SYDNEY SOUTH WEST PLANNING PANEL

SUPPLEMENTARY REPORT

Panel Reference	2015SYW218
DA Number	DA-1212/2015
Local Government Area	Liverpool City Council
Proposed Development	Consolidation of four existing lots, demolition of existing structures and tree removal, and construction of a 6 to 9-storey high residential flat building comprising a total of 101 units over two levels of basement parking. The development provides a unit mix of 15 x 1 bedroom apartments, 73 x 2 bedroom apartments and 13 x 3 bedroom apartments.
Street Address	17-23 Goulburn Street, Liverpool (Lots 1- 4 DP 13932)
Applicant/Owner	Applicant – Mr W Chao Owner – PTA Dermatology
Date of DA Lodgement	11 December 2015
Number of Submissions	Nil
Recommendation	Approval (subject to conditions)
Regional Development Criteria (Schedule 4A of the Act)	The Capital Investment Value of the development is over \$20 million (\$26,483,460)
List of All Relevant s79C(1)(a) Matters	<ul style="list-style-type: none"> • <i>List all of the relevant environmental planning instruments: s79C(1)(a)(i)</i> <ul style="list-style-type: none"> - State Environmental Planning Policy No. 65 – Design Quality of Residential Apartment Development - Sta

Figure 1: View of an alternative scheme re-orienting the building to face Lachlan St, showing the ground level building layout and shadows cast by the building at 9am, 12noon and 3pm in mid-winter.

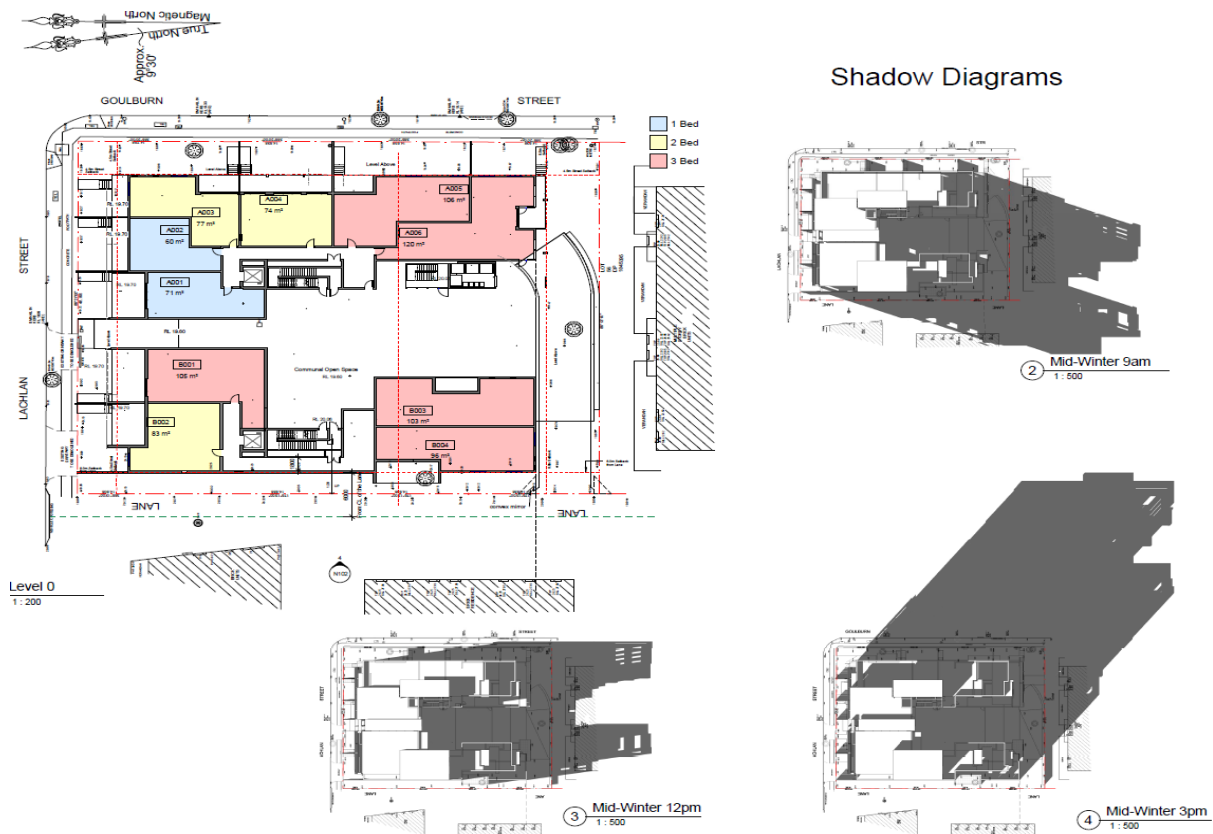
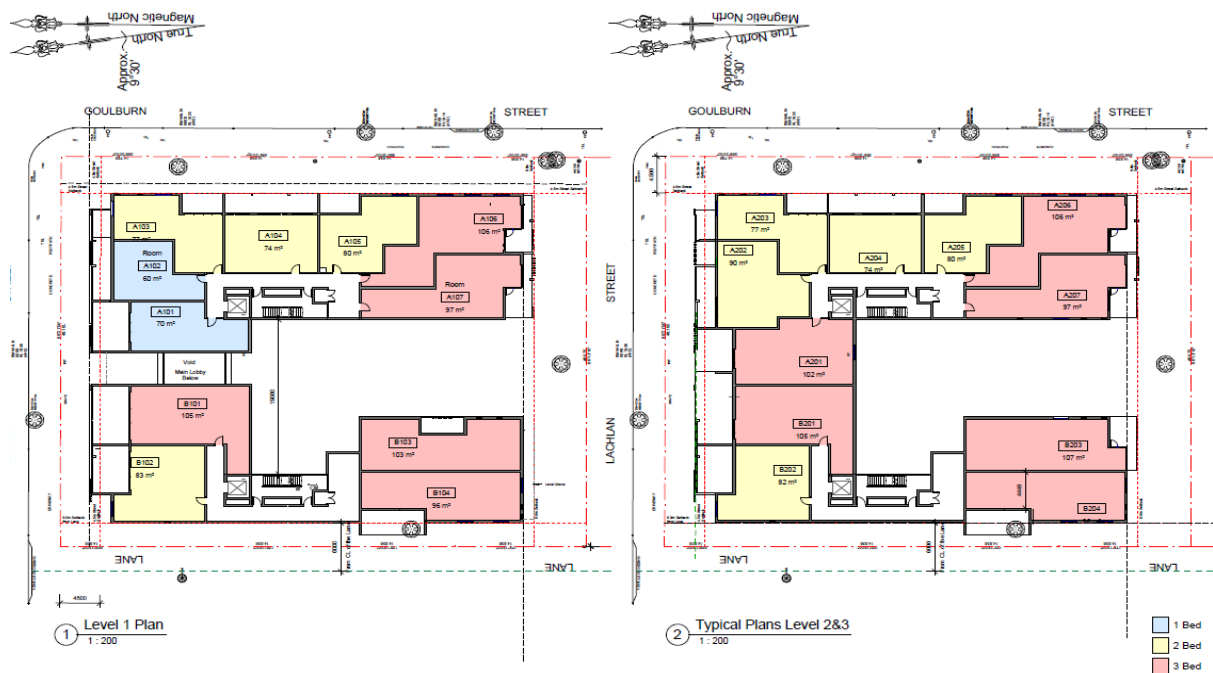
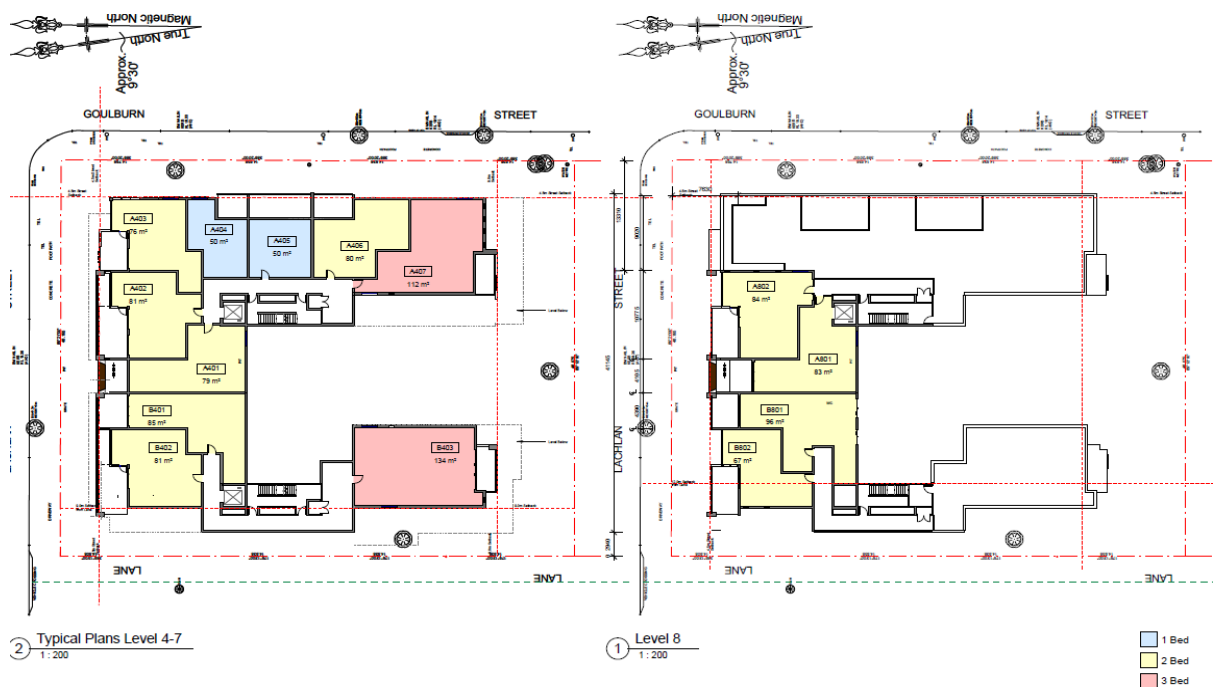
In preparing the alternative scheme for the proposal, the applicant advised that a comparison study was made between the alternative scheme requested by the Panel and the proposed scheme and offered the following comments:

Solar Access:

The proposed application is fully compliant with the requirements of the ADG (SEPP65). The scheme represents 72% (73 Units of 102) of the units receiving a minimum 1m² of solar access for 2 hours between 9am and 3pm on the winter solstice.

The alternate design, does not comply with the requirements of the ADG (SEPP65). Only 68.9% (60 Units of 87) of the units will receive the required solar access.

Therefore, the alternative scheme will receive less solar access when compared to the original scheme.

Shadow Impact on the adjoining development:

It is evident that the shadow impact from the alternate scheme design on the adjoining development at 25-27 Goulburn Street in comparison to the proposed development indicates no reduction in shadow impact in the morning and afternoon diagrams.

The alternate scheme illustrates only a minor improvement in shadow impact during the midday time slot.

Communal Open space on Ground floor:

It is evident that 30-50% of communal open space will receive solar access between 12pm and 3pm in the original scheme.

It is evident that the alternate scheme will receive minimal to zero solar access in the winter solstice due to the southern orientation. In addition to this, the alternate scheme will implicate further privacy issues to the communal open space as it is in direct view of the southern neighbouring property.

Design and Development Yield:

It is evident that the proposed site is rectangular in shape, with any degree of rotation will implement a reduction in developable residential units. With reference to the alternate scheme, the total number of units is reduced from 102 to 87 units. If a re-design is required, amended project documentation must be compiled and then be provided to council for re-assessment; this process will significantly burden the applicant in terms of time and resources.

To conclude our findings, it is clearly apparent that the Original Scheme is compliant with the requirements of the ADG (SEPP65). With respect to the planning panel, the applicant has provided sincere consideration to an alternate design, which has concluded that the Original Scheme will produce a better design outcome.

Council was not satisfied that the alternative scheme of rotating the building to face Lachlan Street would represent a superior planning outcome. Whilst the alternative scheme demonstrates that solar access to the southern adjoining residential flat building is improved at midday, solar access to the ground level communal open space of the development is significantly compromised in that the ground level communal open space will receive no solar access at all. The original proposal allows solar access to the ground level communal open space in the afternoon at the winter solstice.

Figure 5: View of Levels 4-7 of the amended proposal, consisting of a 9-storey building facing Goulburn St and Lachlan St and a 6-storey south wing facing Goulburn Lane. The rooftop communal open space on top of the north wing of the building has been replaced with apartments.

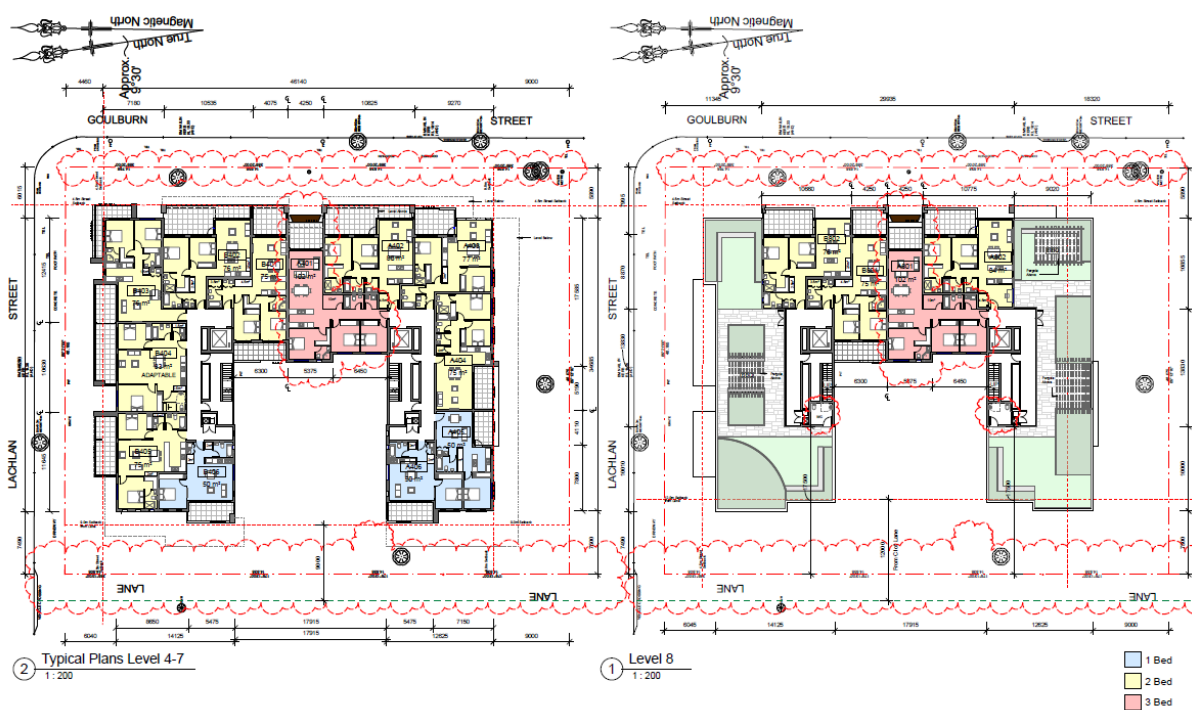
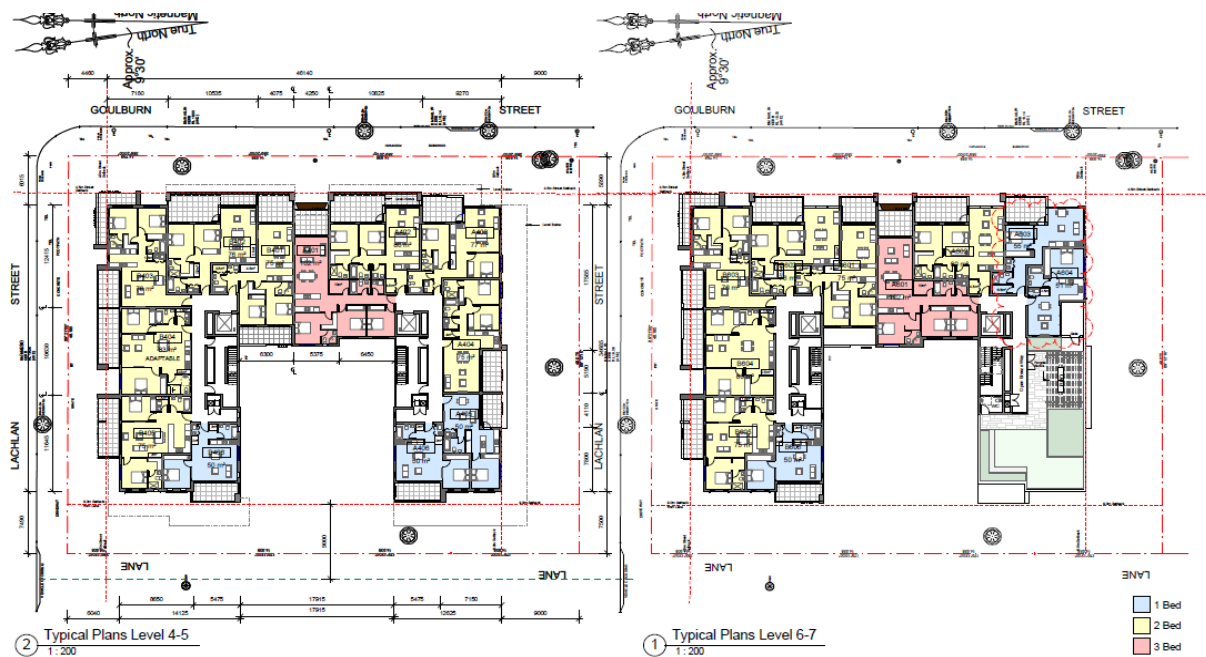
- i. The south wing of the proposed U-shaped building has been lowered from 8 storeys to 6 storeys. In doing so, 6 apartments (4 x 1-bedroom and 2 x 2-bedroom apartments) have been deleted. A rooftop communal open space, featuring a barbeque area, landscape area and WC facility, is now provided on top of the reduced south wing of the building.
- ii. The north wing of the building facing Lachlan Street has been increased from 8 storeys to 9 storeys. The 6 deleted apartments from the south wing have been relocated to the top floor of the north wing of the building. The previous rooftop communal open space on top of the north wing has been replaced with apartments (1 x 1-bedroom and 3 x 2-bedroom apartments). There is a net loss of 1 apartment.

- iii. The amended proposal has improved solar access and cross-ventilation to the residential apartments in comparison to the original proposal. That is, solar access to the residential apartments has been increased from 72% to 74% (minimum required is 70%), whilst cross-ventilation has been increased from 65% to 67% (minimum required is 60%). However, it must be noted that the quantum of communal open space for the development has been reduced from 1081m² to 788m² as a result of the removal of the rooftop communal open space from the north wing of the building. Consequently, and as demonstrated by the applicant, solar access to the communal open space has been reduced. Given that the revised communal open space, equivalent to 27% of the site area, exceeds the minimum required of 25% of the site, the slight reduction of solar access to the communal open space is not considered to be unreasonable as solar access to the southern adjoining residential flat building has been improved and solar access to the residential apartments has also been improved.

- iii. The increased building height to the north wing of the building facing Lachlan Street from 8 storeys to 9 storeys is still within the allowable building height for the site of 35m (29.25m proposed).

Figure 7: View of shadows cast by the amended proposal at the critical hours of 9am, 12noon and 3pm at mid-winter. The extent of shadows cast upon the southern adjoining sites have been reduced as a result of lowering the south wing of the building from 8-storey to 6-storey.

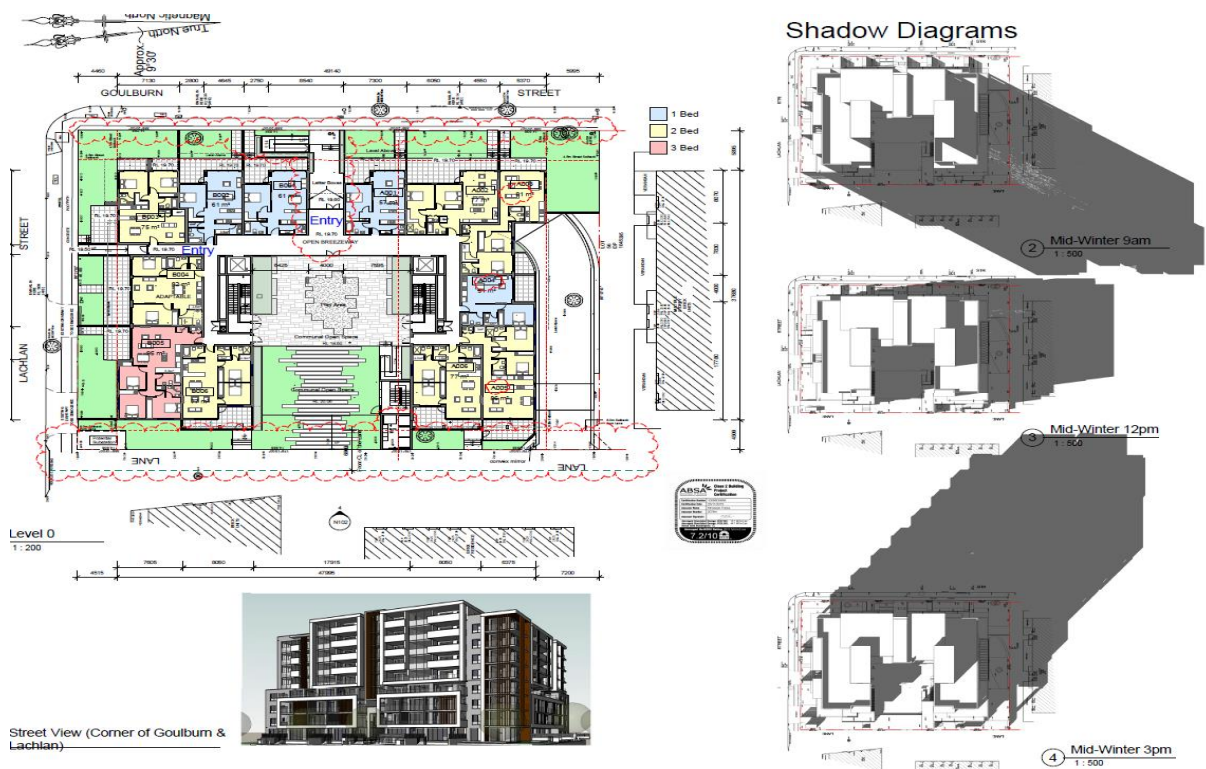
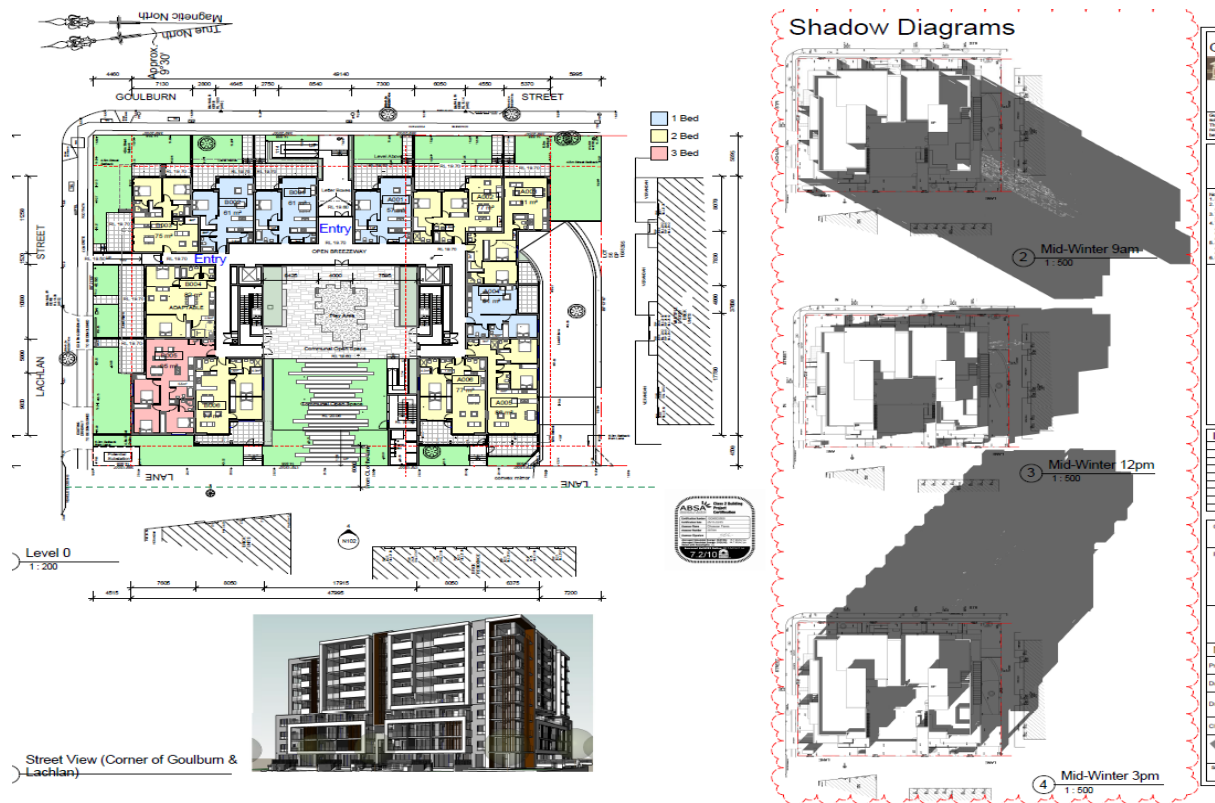
- i. The reduction of the height of the south wing of the building from 8 storeys to 6 storeys has marginally improved solar access to the southern adjoining residential flat building particularly at 12noon and 3pm at the winter solstice. This is an improvement from the original proposal.
- ii. This reduction in building height to the south wing has significantly improved the relationship between the proposed development and the 4-storey southern adjoining residential flat building in terms of bulk and scale.

- iv. Council's assessment indicates the following with respect to solar access to the communal open space of the development (as amended):
 - a. Approximately 65% (96m² out of 147m²) of the rooftop communal open space on top of the 6-storey wing will receive solar access at 12noon at the winter solstice;

- b. Approximately 61% (90m² out of 147m²) of the rooftop communal open space on top of the 6-storey wing will receive solar access at 3pm at the winter solstice; and

- c. Approximately 52% (280m² out of 540m²) of the ground level communal open space will receive solar access at 3pm at the winter solstice.
 - d. Solar access to the ground level communal open space between the original proposal and the amended proposal remain the same.

Figure 9: View of shadows cast by the amended proposal demonstrating that shadow impact upon the southern adjoining residential flat building is marginally improved at 12noon and 3pm at mid-winter.

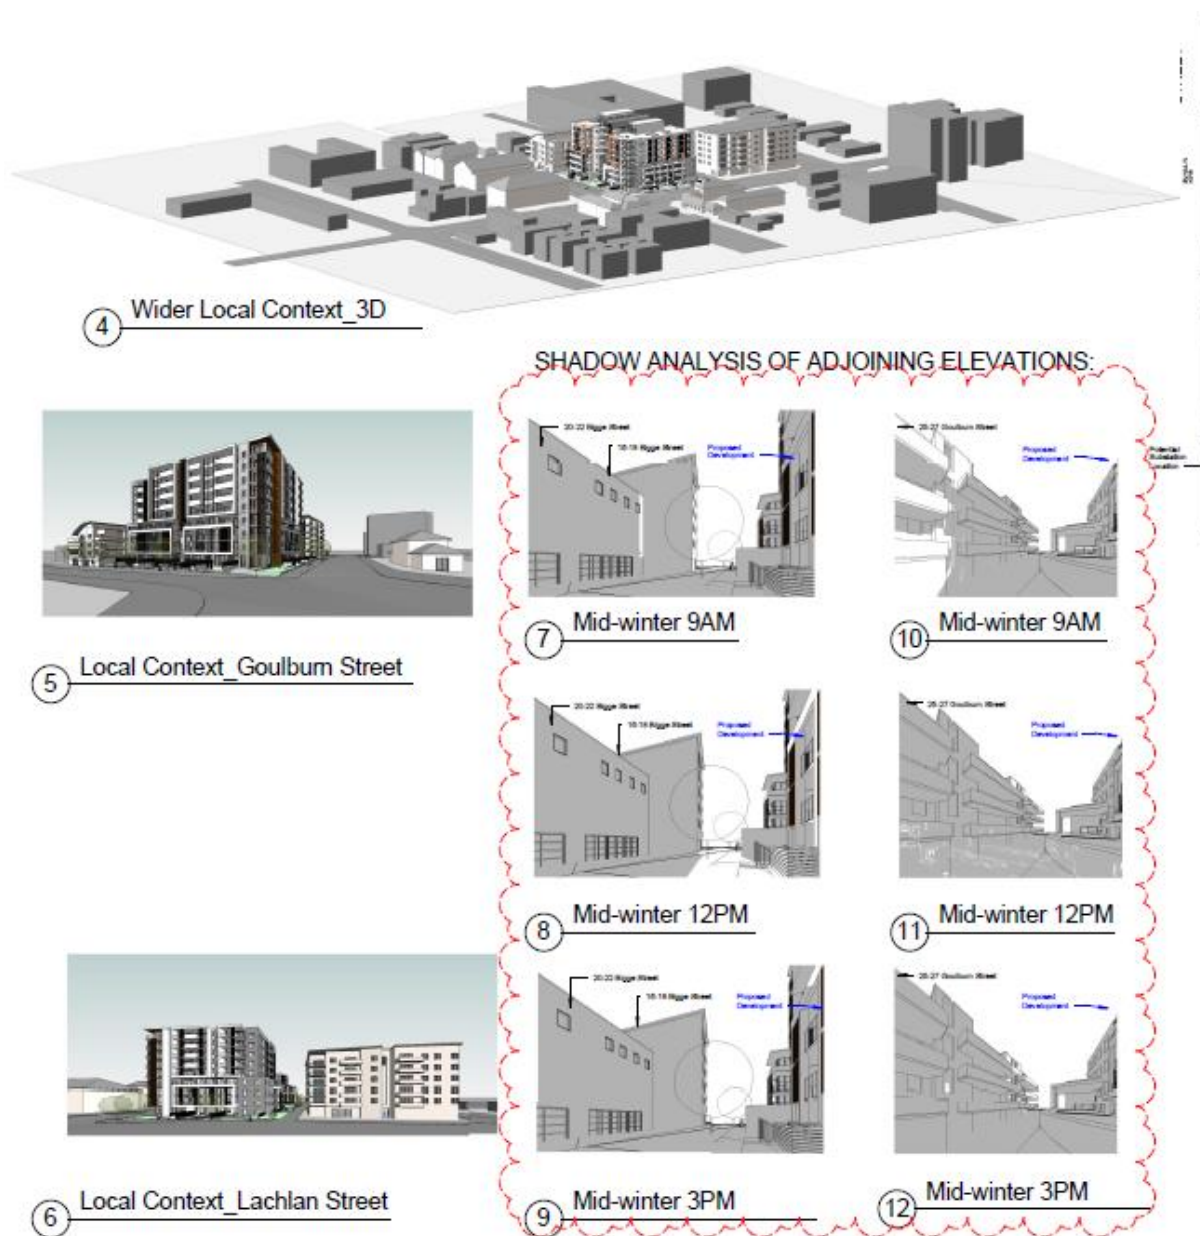
- *It is evident that the shadow impact from the suggested Scheme design on the adjoining development at 25-27 Goulburn Street in comparison to the proposed development indicates no reduction in shadow impact. However, the plans shows a minor reduction in shadows casting on the surrounding buildings in the suggested scheme when compared to the original scheme.*
